The 55 details drawn differently in CAD and Revit

Checked against the new drafters' file, 26 October.

55 of the 190 CAD typical details have a Revit version in your templates that is drawn differently. Each page: your CAD detail on the left, the Revit version on the right, what differs, and one answer: CAD is right, Revit is newer (we update CAD from it), or both wrong.

13 of 55 CAD: KOR-D202-DET 08 - TYPICAL SECTION THRU CORE FOOTING AT ELEVATOR PIT

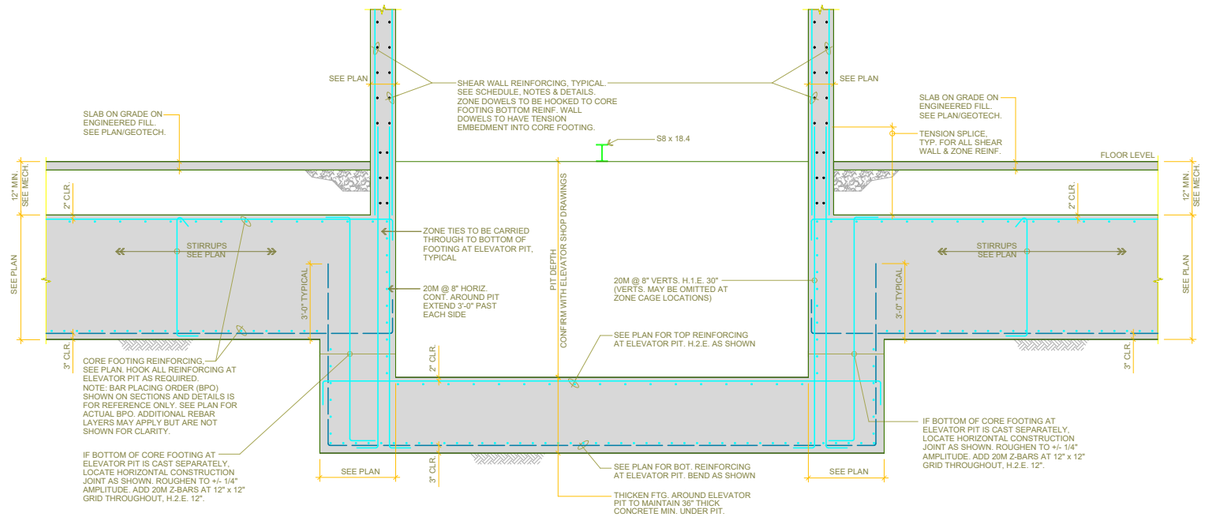
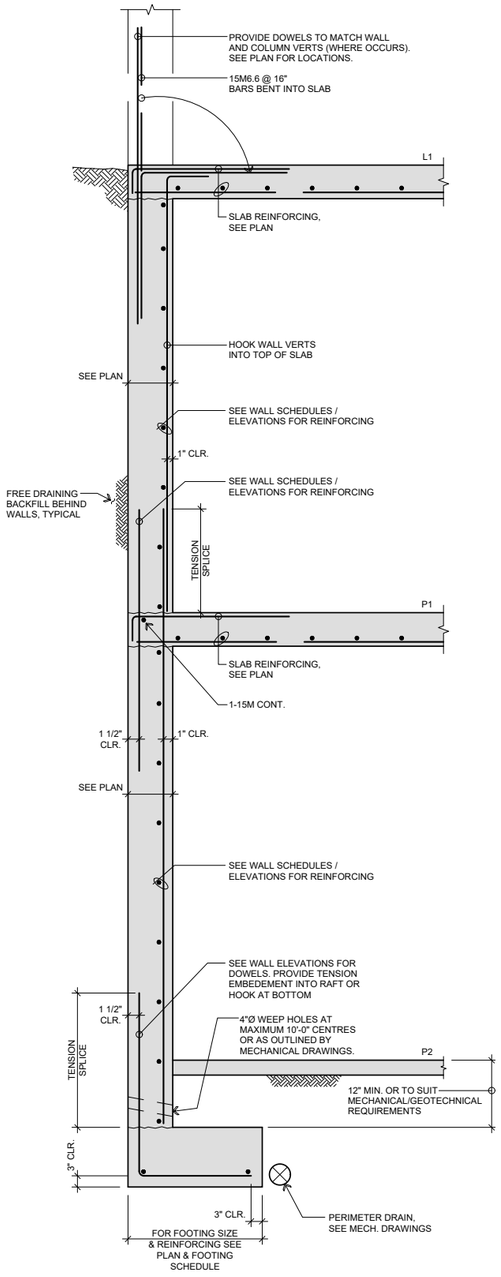
What differs: Core footing with sloped sides, divider beam and lap notes; 'S6.01_2_CORE FOOTING SECTION THRU ELEVATOR PIT' has vertical steps and no divider.

CAD: KOR-D301-DET 02 - BASEMENT WALL SECTION

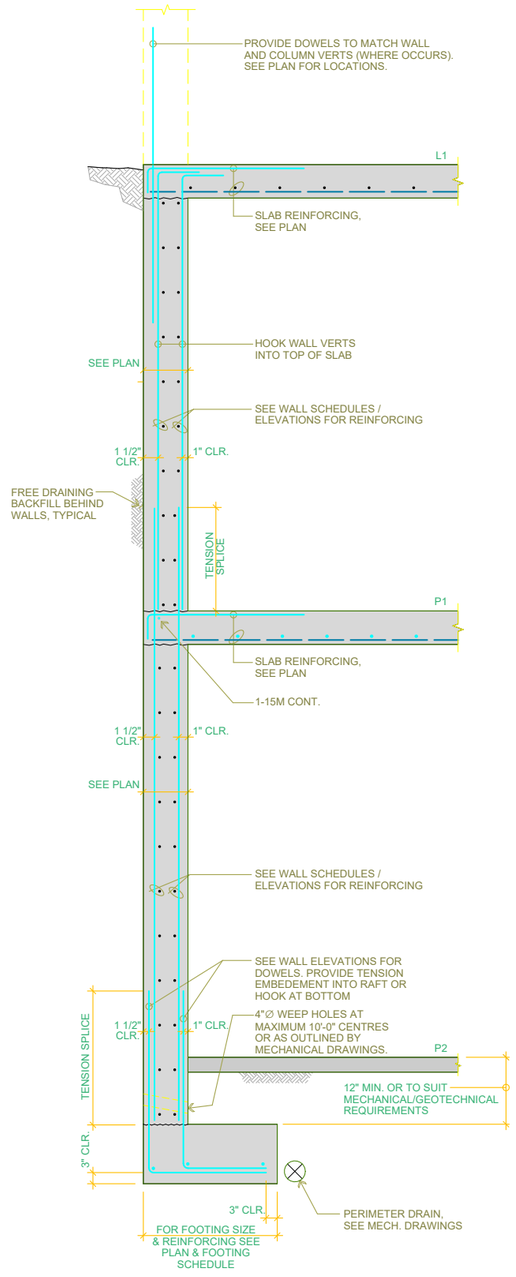
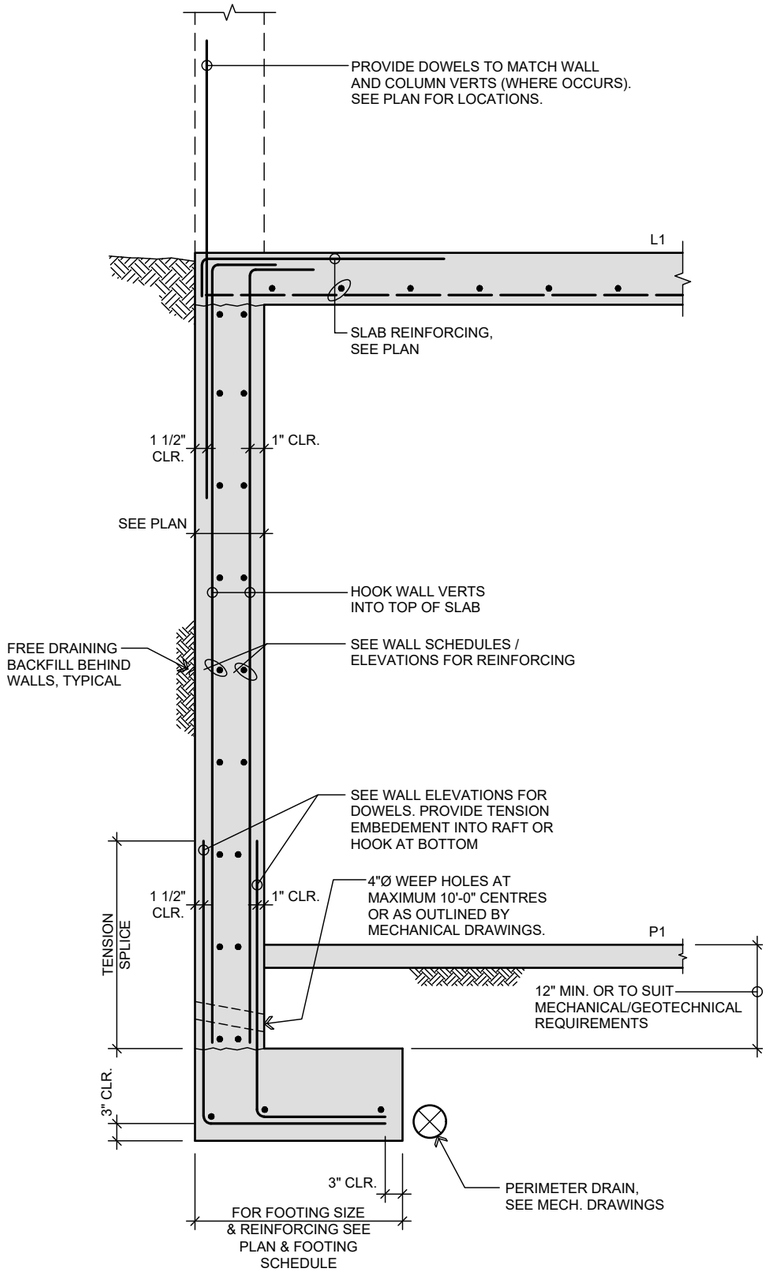
What differs: Same basement wall section but adds a wall-reinforcing-per-schedule callout and 15M bent bars that 'D3.01_1_BASEMENT WALL SECTION' lacks.

CAD: KOR-D301-DET 03 - BASEMENT WALL SECTION

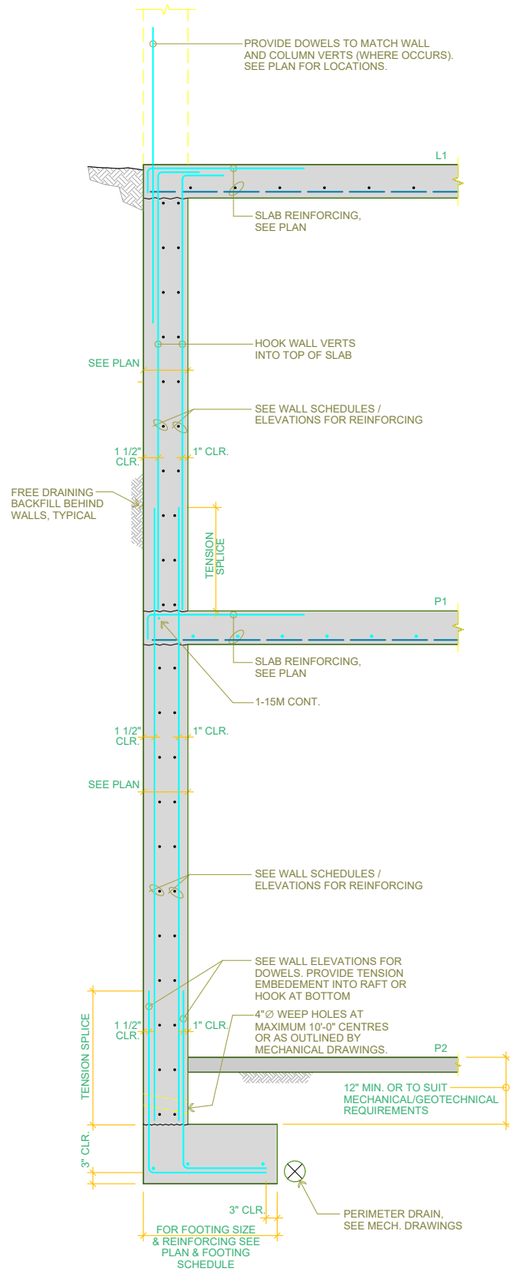
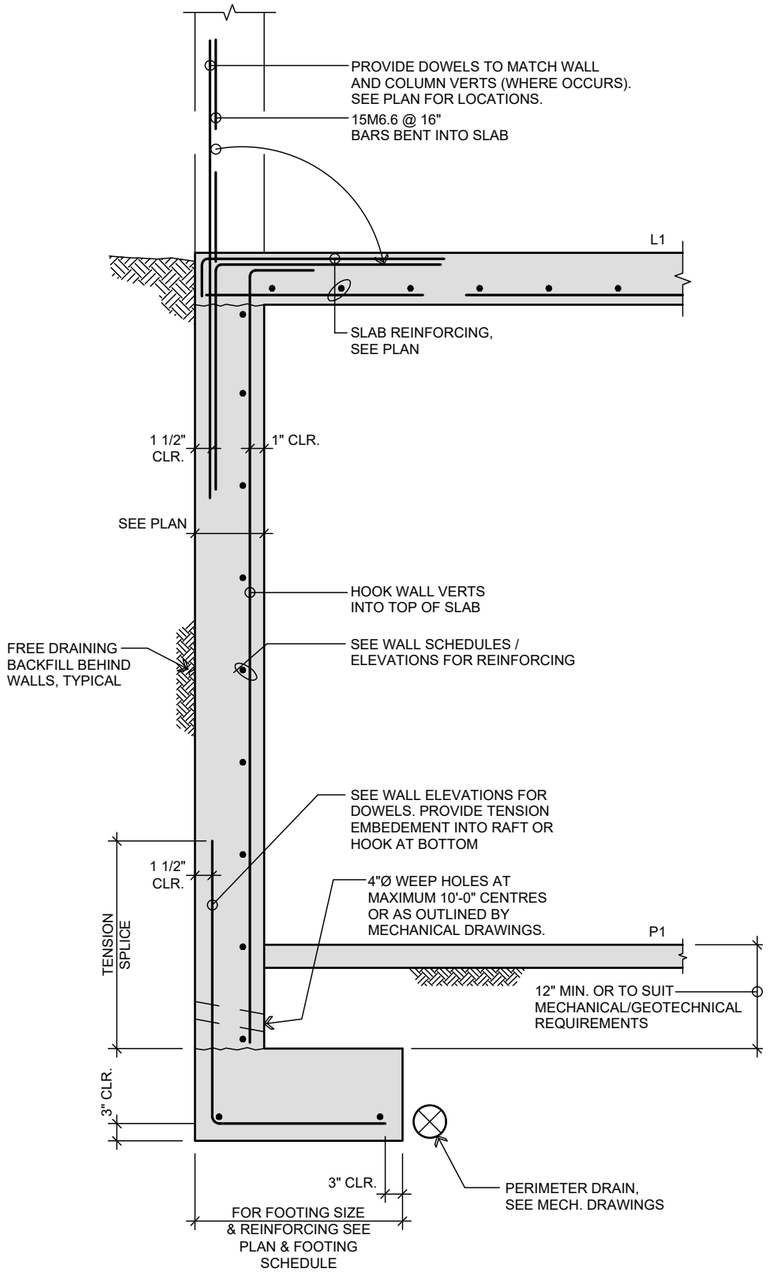
What differs: Single-storey basement wall with one slab and strip footing; 'D3.01_1_BASEMENT WALL SECTION' shows three suspended levels.

CAD: KOR-D301-DET 04 - BASEMENT WALL SECTION

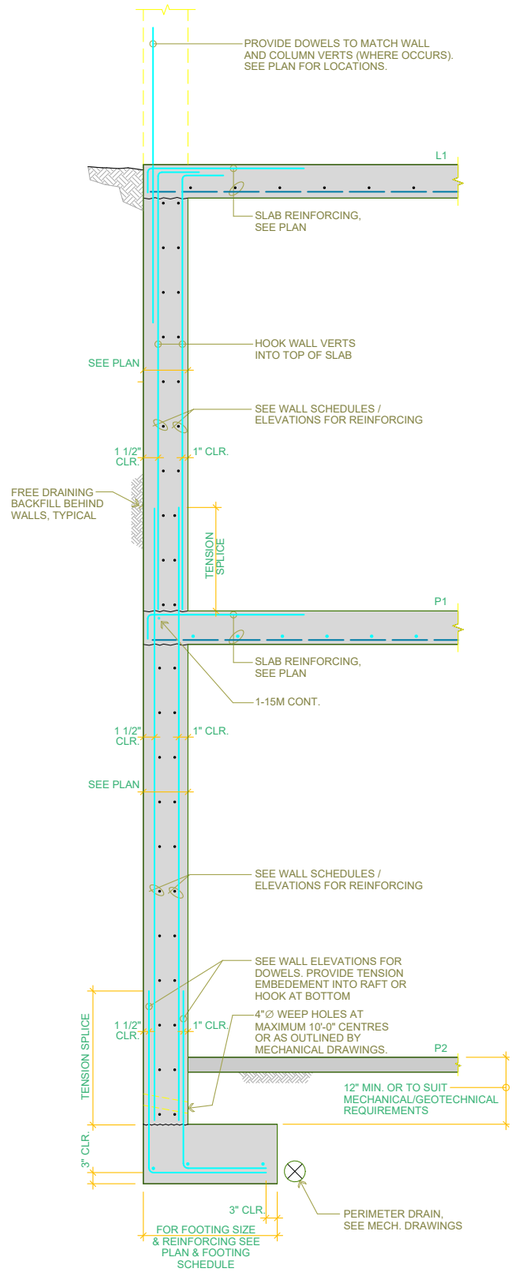
What differs: Single-storey basement wall with slab dowels and footing; 'D3.01_1_BASEMENT WALL SECTION' shows three levels.

Revit: D3.01_1_BASEMENT WALL SECTION (Typical Details - Container_R23 (Need_MET & IMP).rvt; on D3.01 Series 3 Basement)

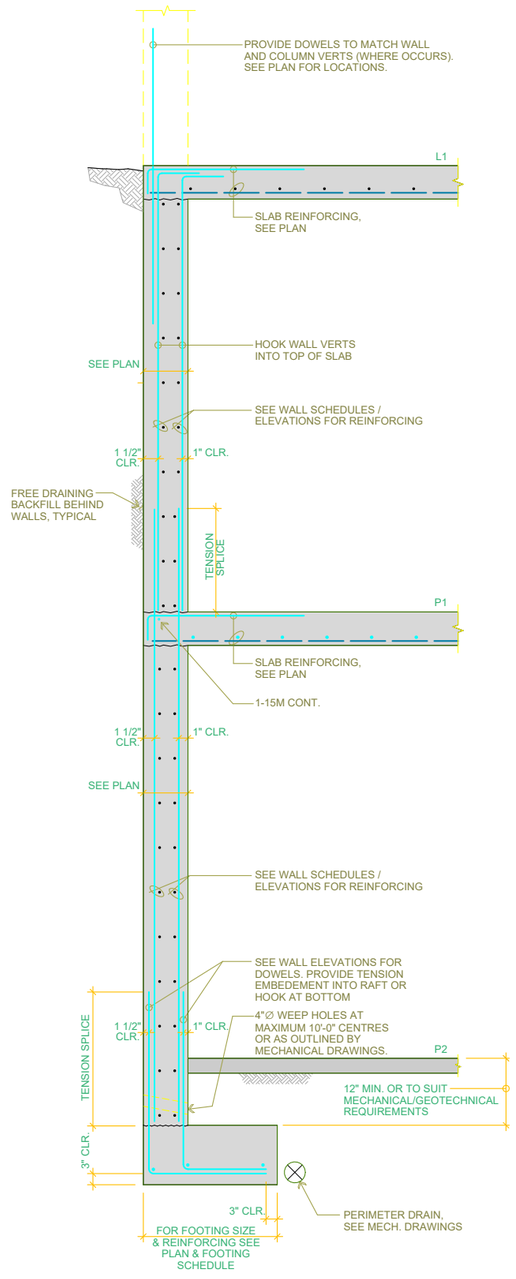
What differs: Tall multi-storey wall with five slabs; 'D3.01_1_BASEMENT WALL SECTION' shows three levels and different callouts.

Revit: D3.01_1_BASEMENT WALL SECTION (Typical Details - Container_R23 (Need_MET & IMP).rvt; on D3.01 Series 3 Basement)

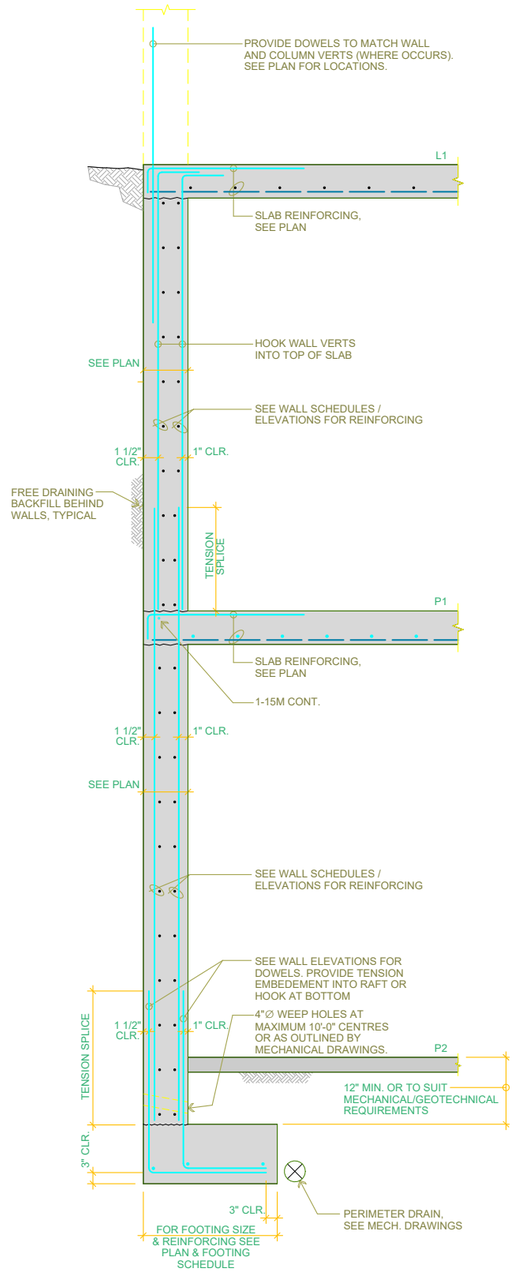
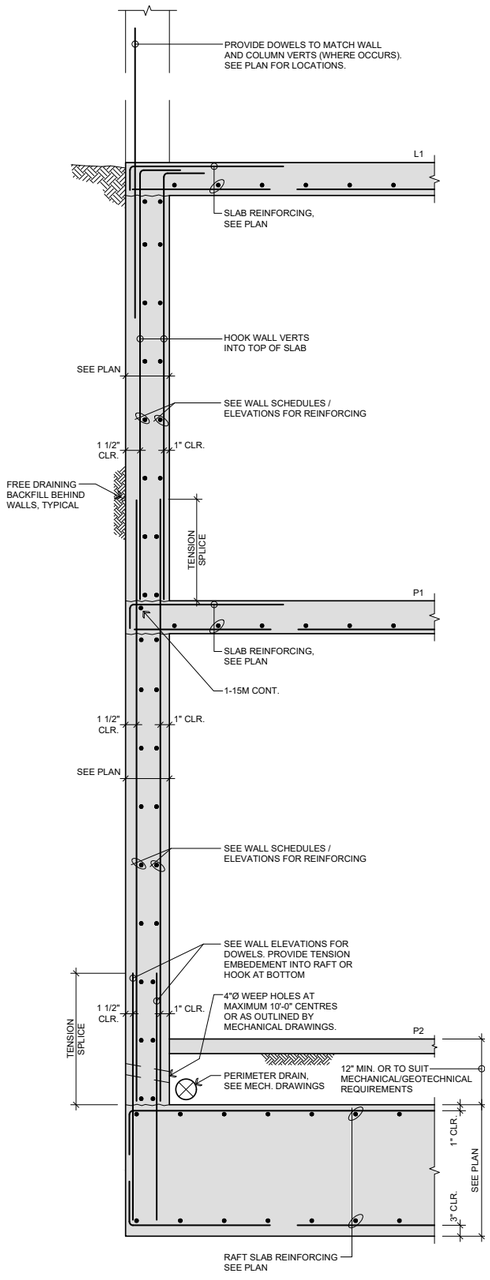
What differs: Tall multi-storey wall with five slabs; 'D3.01_1_BASEMENT WALL SECTION' shows three levels and different callouts.

CAD: KOR-D302-DET 01 - BASEMENT WALL SECTION

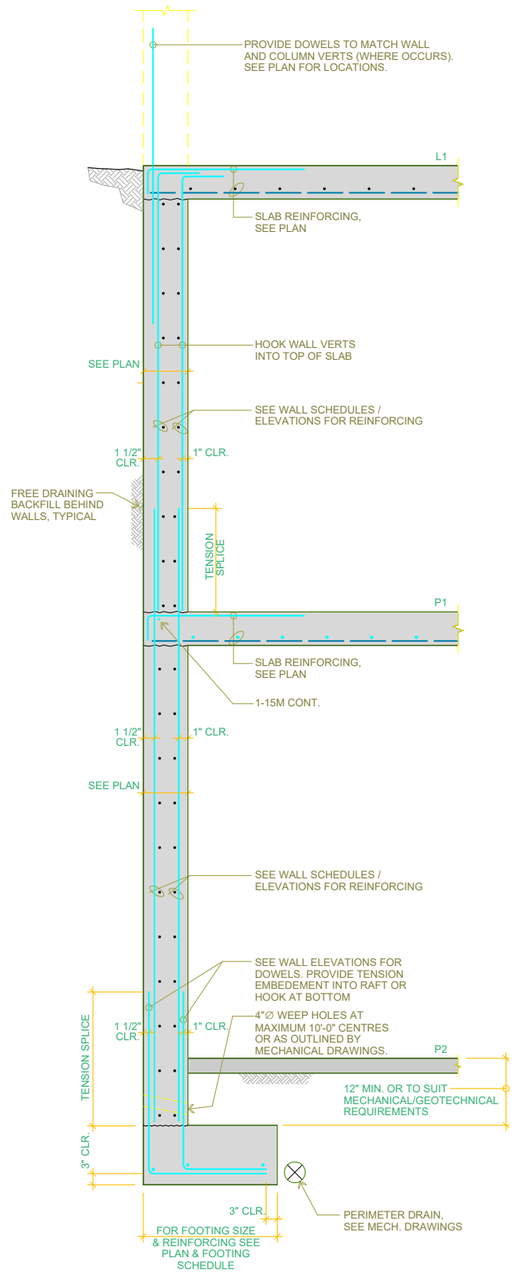
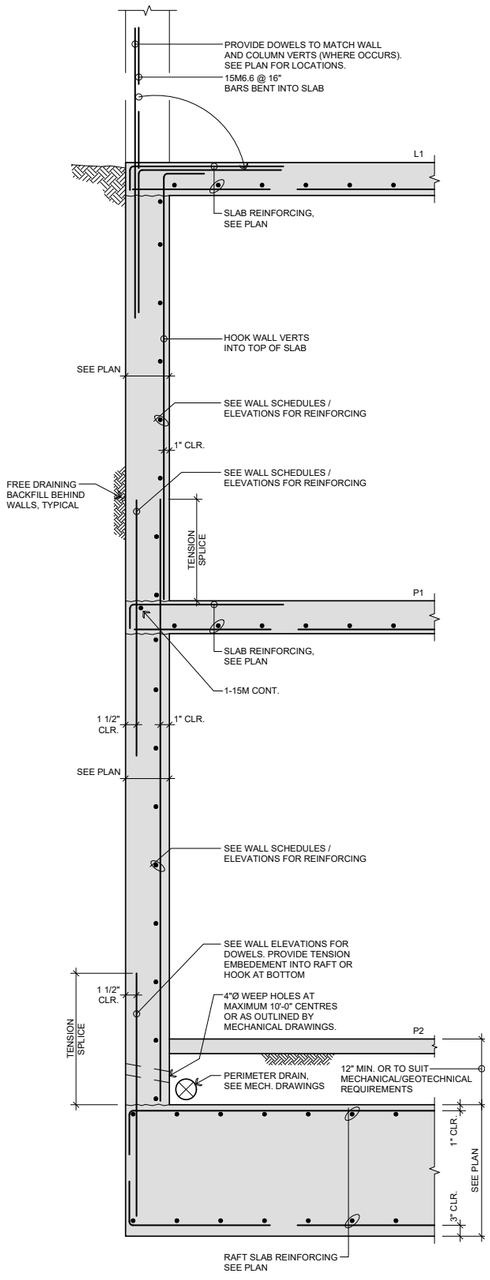
What differs: Basement wall section bearing on a raft instead of a strip footing; otherwise like 'D3.01_1_BASEMENT WALL SECTION'.

CAD: KOR-D302-DET 02 - BASEMENT WALL SECTION

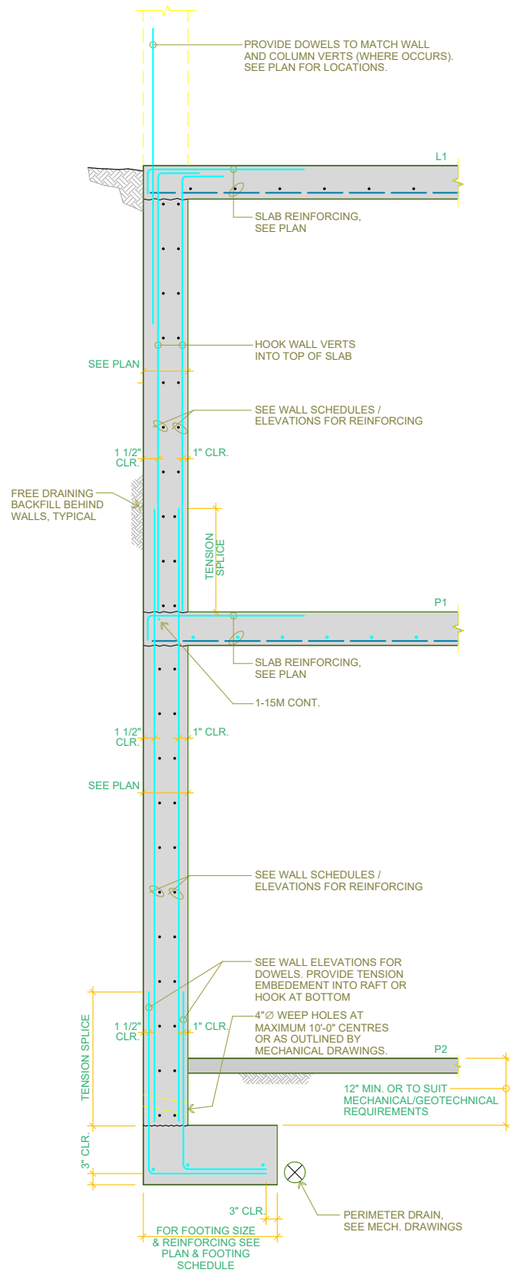
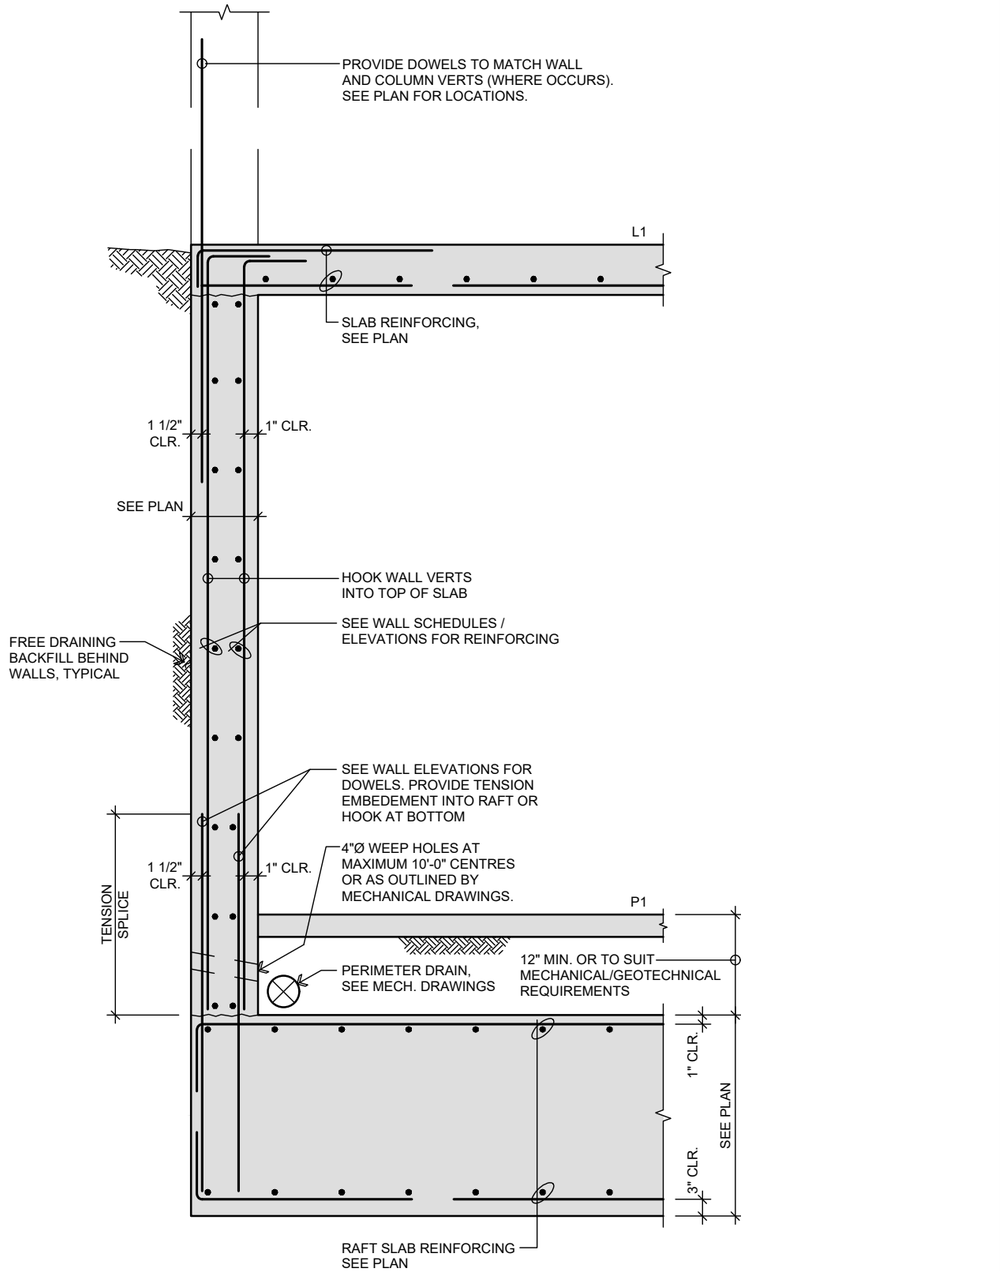
What differs: Basement wall on a raft with extra callouts vs 'D3.01_1_BASEMENT WALL SECTION''s strip footing.
